**PECOS DISTRICT  
CONDITIONS OF APPROVAL**

30-015-39359

OPERATOR'S NAME:	CIMAREX ENERGY CO. OF COLORADO
LEASE NO.:	BHL: NM120888 SHL: 111949
WELL NAME & NO.:	SARVIS 3 FEDERAL COM # 3
SURFACE HOLE FOOTAGE:	1980' FSL & 0400' FEL
BOTTOM HOLE FOOTAGE:	1980' FSL & 0660' FWL
LOCATION:	Section 3, T. 26 S., R. 26 E., NMPM
COUNTY:	Eddy County, New Mexico

### Cross Section of a Typical Lead-off Ditch

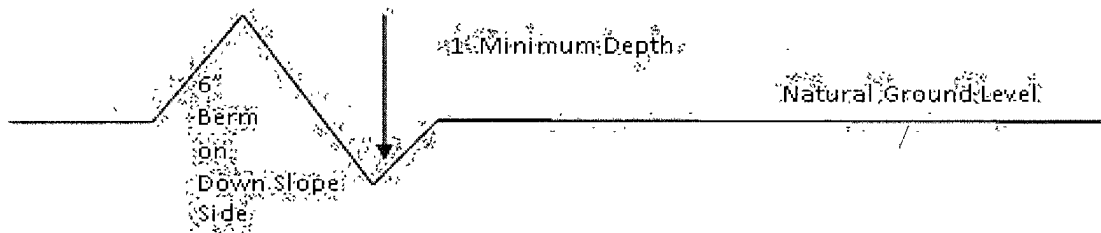
A typical lead-off ditch has a minimum depth of 1 foot below and a berm of 6 inches above natural ground level. The berm shall be on the down-slope side of the lead-off ditch.

All lead-off ditches shall be graded to drain water with a 1 percent minimum to 3 percent maximum ditch slope. The spacing interval are variable for lead-off ditches and shall be determined according to the formula for spacing intervals of lead-off ditches, but may be amended depending upon existing soil types and centerline road slope (in %);

Figure 1 – Cross Sections and Plans For Typical Road Sections

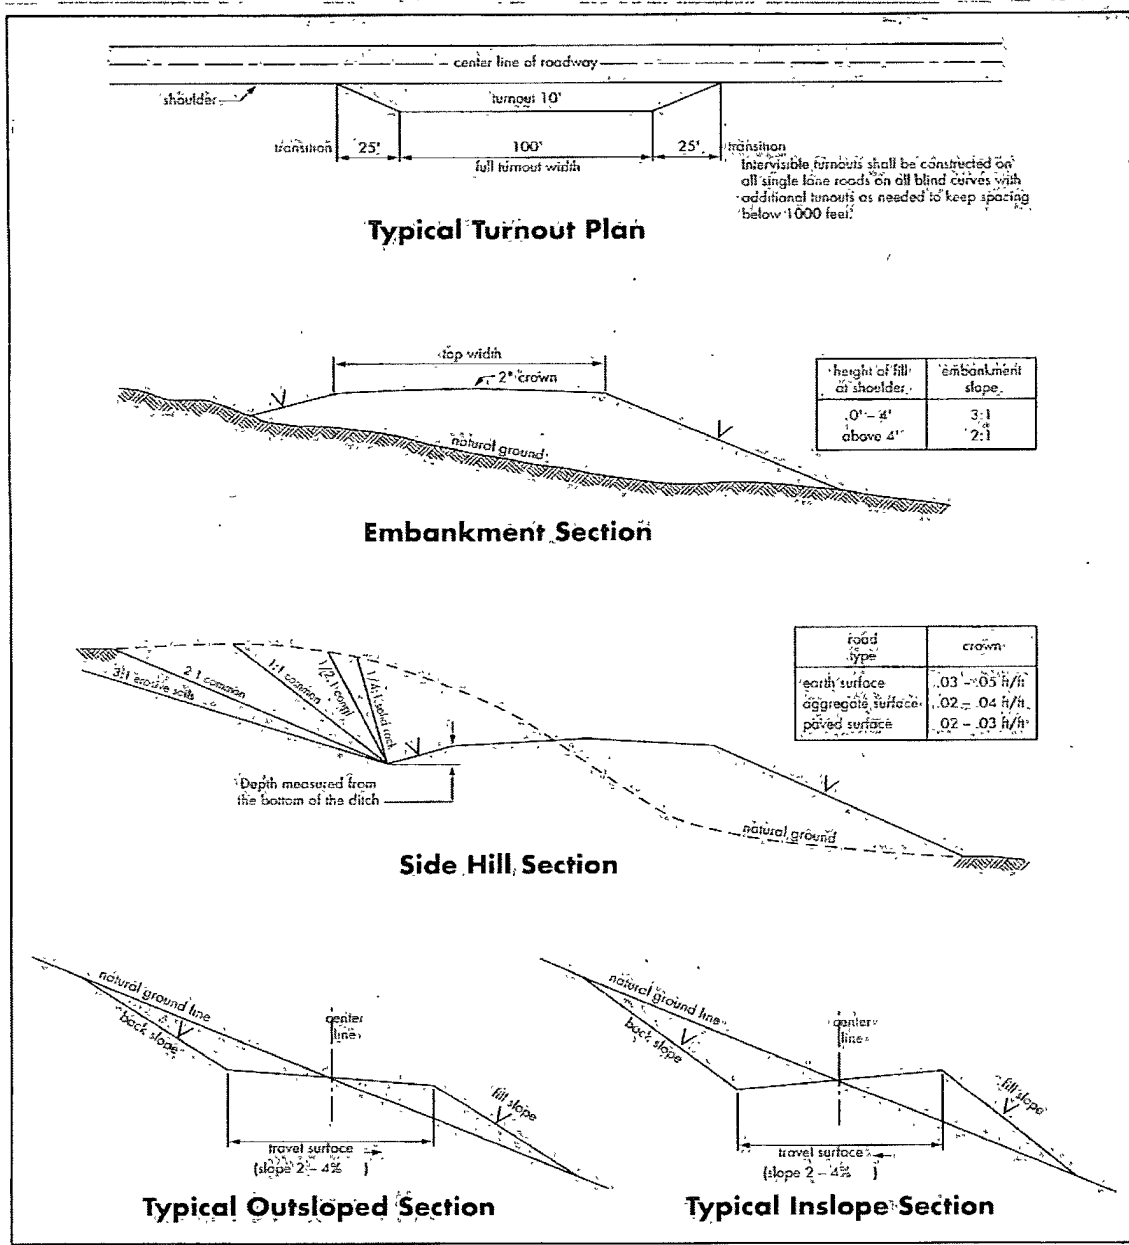
Crowning shall be done on the access road driving surface. The road crown shall have a grade of approximately 2% (i.e., a 1" crown on a 14' wide road). The road shall conform to Figure 1; cross section and plans for typical road construction.
